## ORIGINATION FORM

### Proposed Revisions to a Standard Plans Index

Index Number: 641-020

Index Title: CONCRETE CCTV POLE

SHEET  
2 of 5

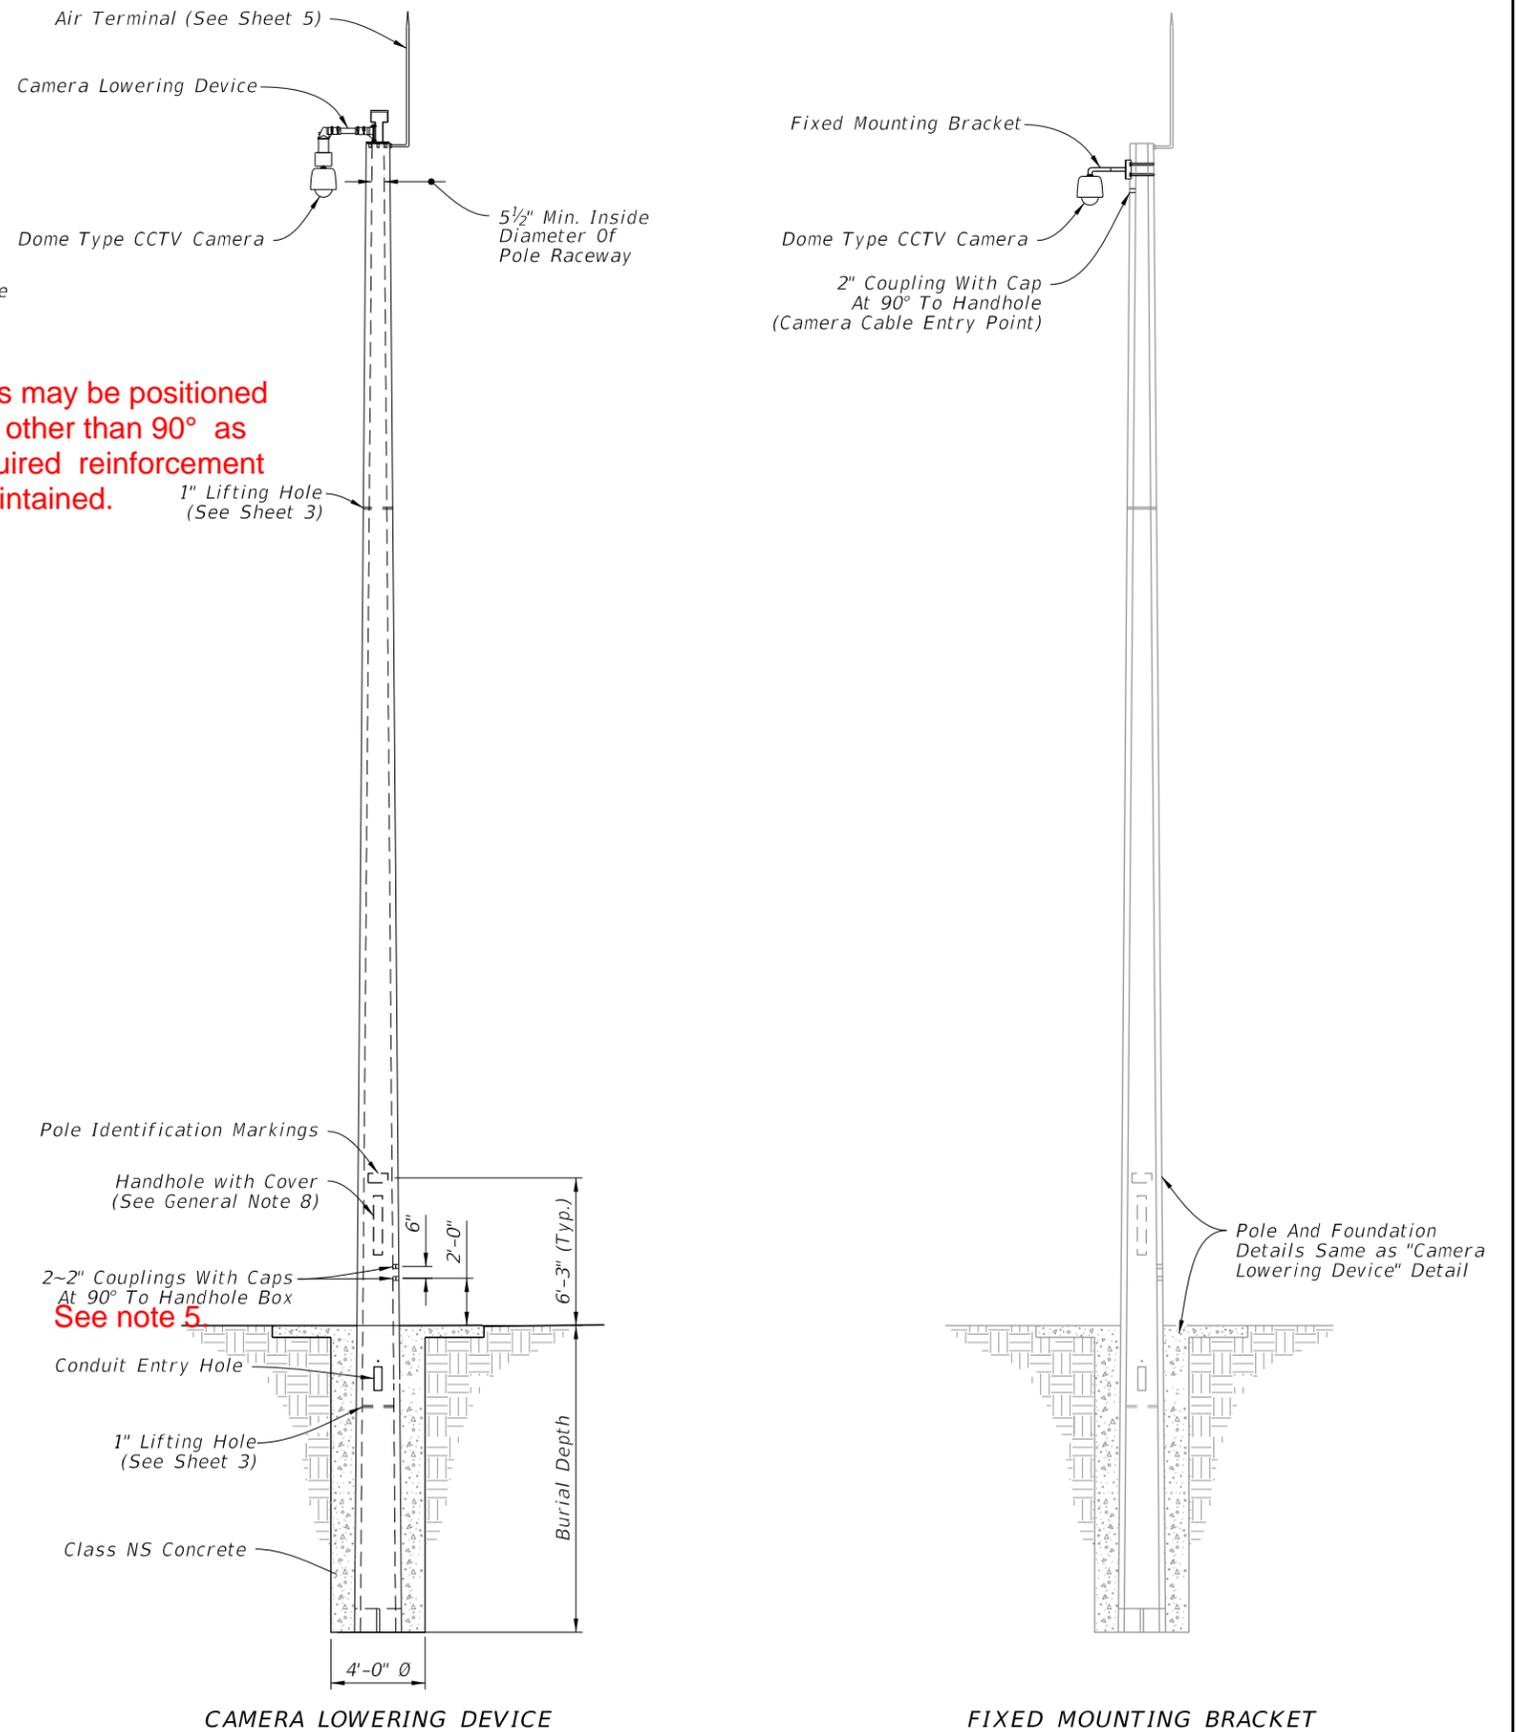
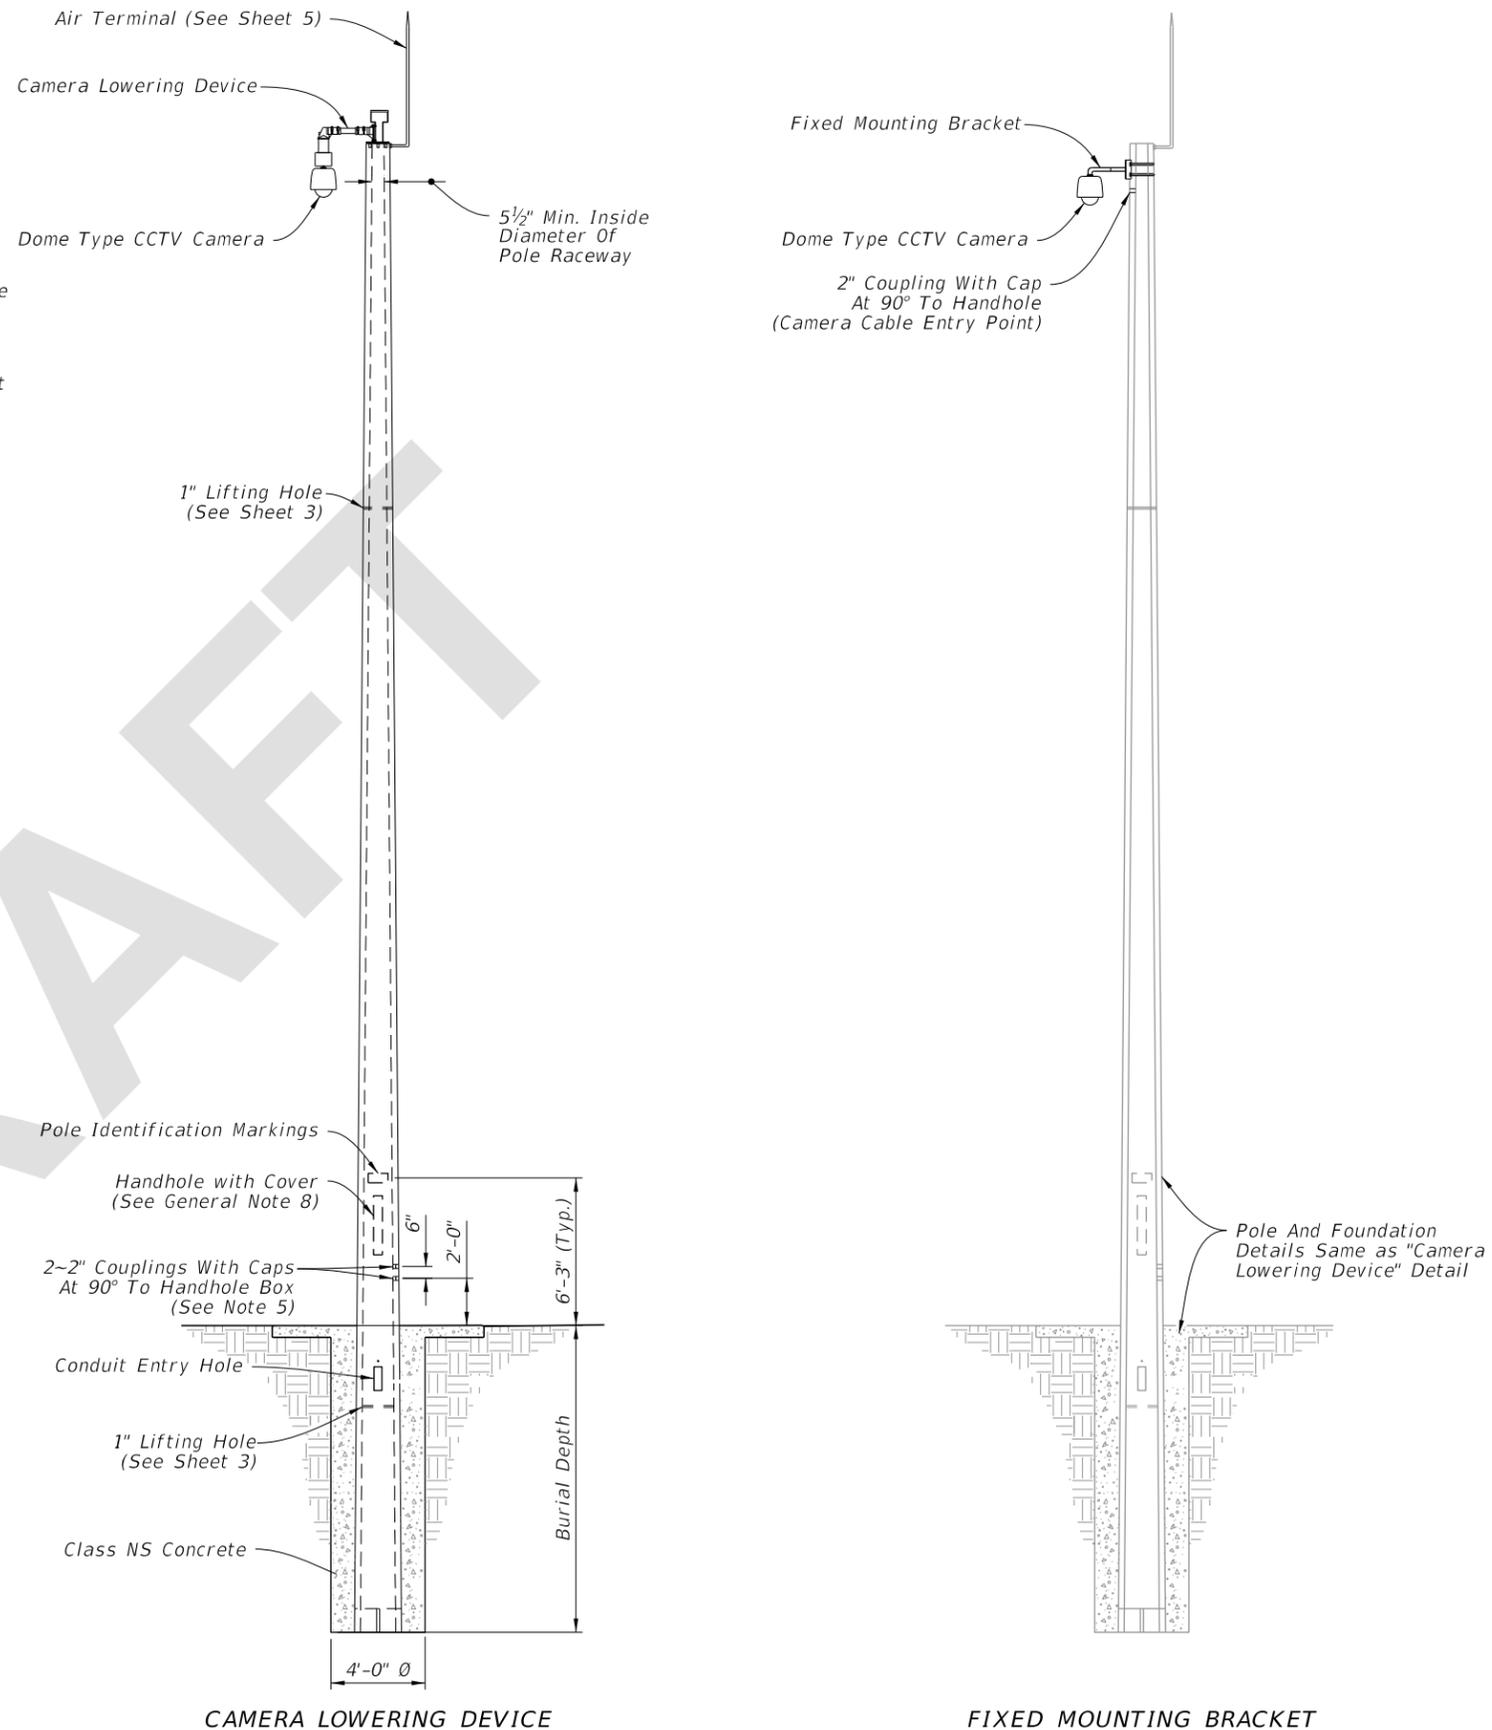
Sheet 2: Added a note allowing the couplers to be positioned at other radial locations.

Sheet 2: Fabricators asked if could position the cabinets at other locations radially. We added a note to allow this.

5. Couplings may be positioned at locations other than 90° as long as required reinforcement cover is maintained.

LAST REVISION 11/01/21	REVISION 11/01/23	DESCRIPTION:	FDOT FY 2023-24 STANDARD PLANS	CONCRETE CCTV POLE	INDEX 641-020	SHEET 3 of 5
---------------------------	----------------------	--------------	--------------------------------------	--------------------	------------------	-----------------

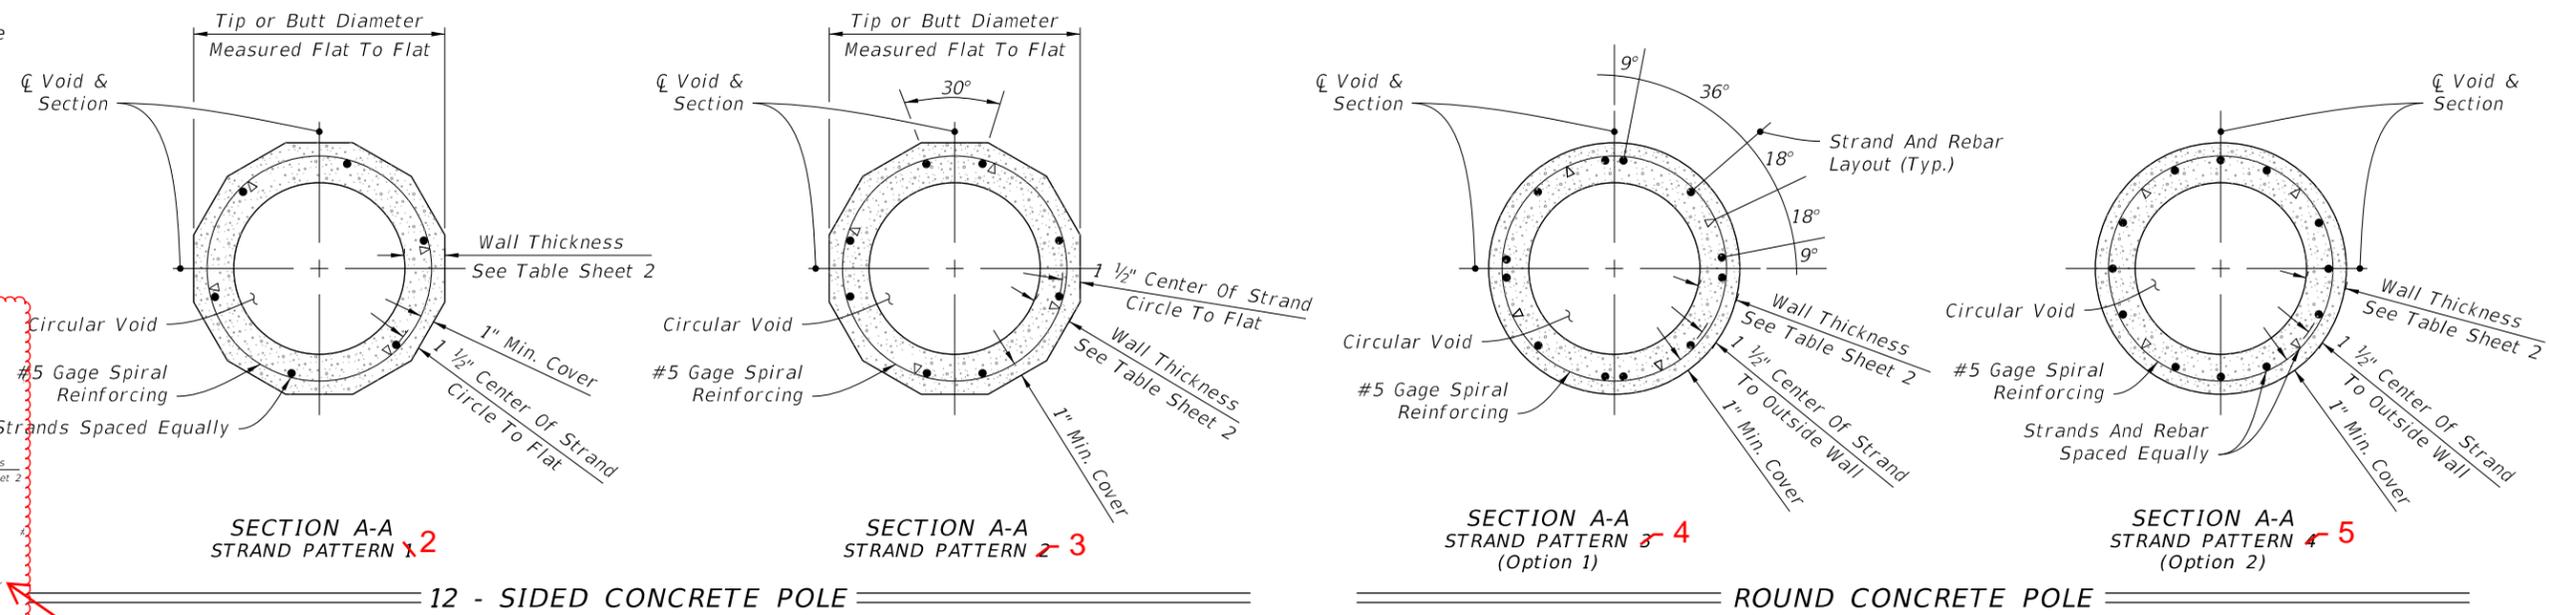
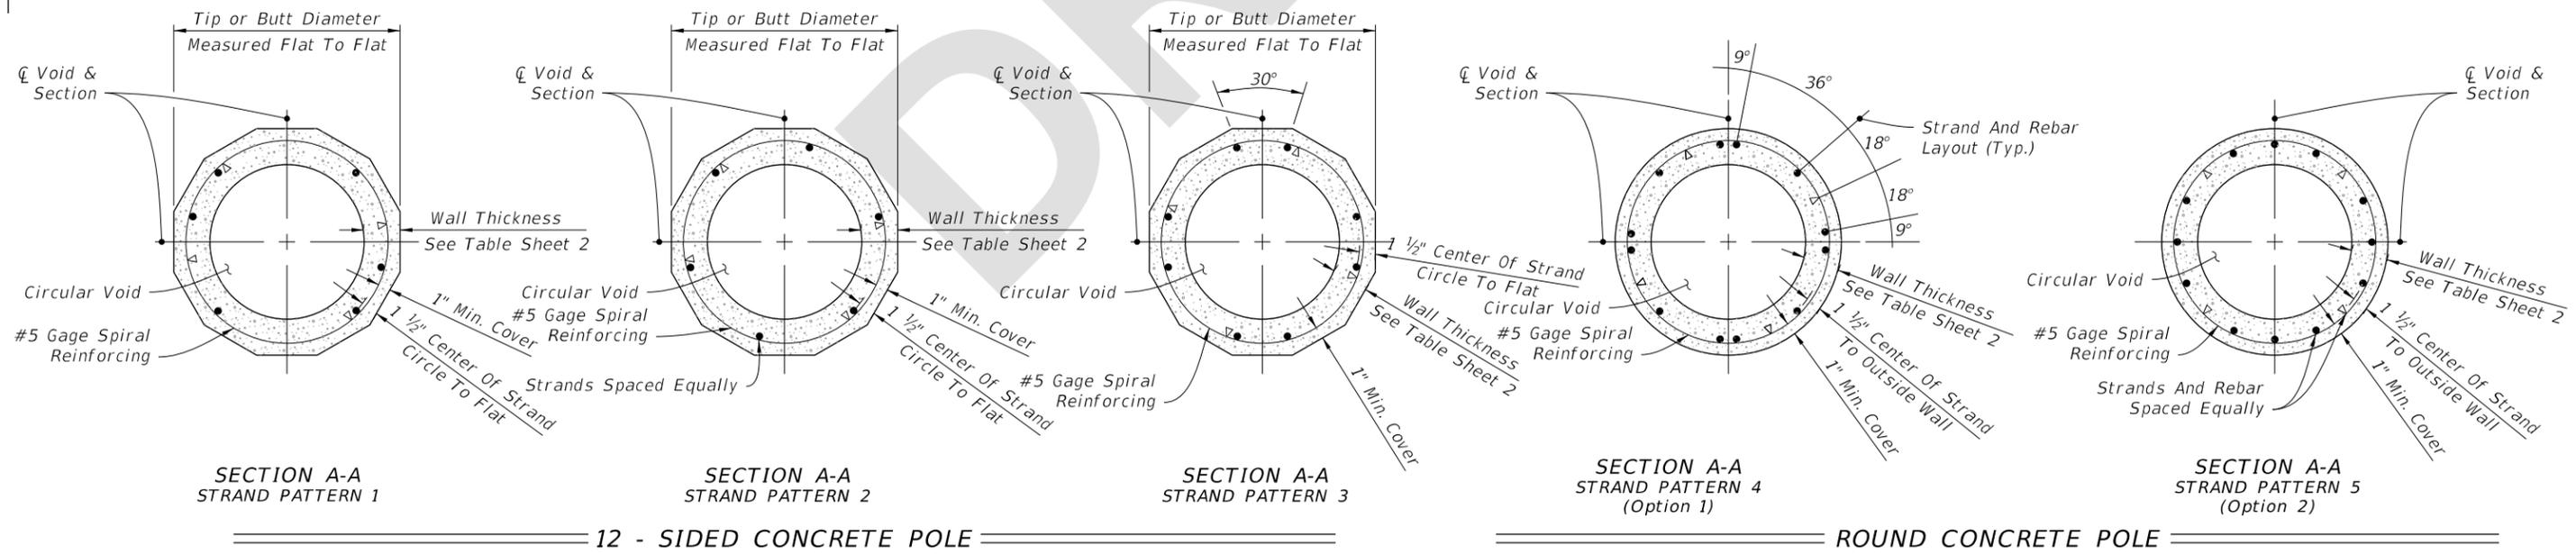
Sheet 3: Added a new strand pattern.

Sheet 3: A fabricator of 12 sided poles had an approved strand pattern in their QC plan which differed from the Standard. The difference allowed the fabricator to mount the hand hole on the flat of the pole and maintain reinforcement cover. We have adopted this in the Standard to provide consistency between the QC plan and the Standard.

Added New Strand Pattern Detail
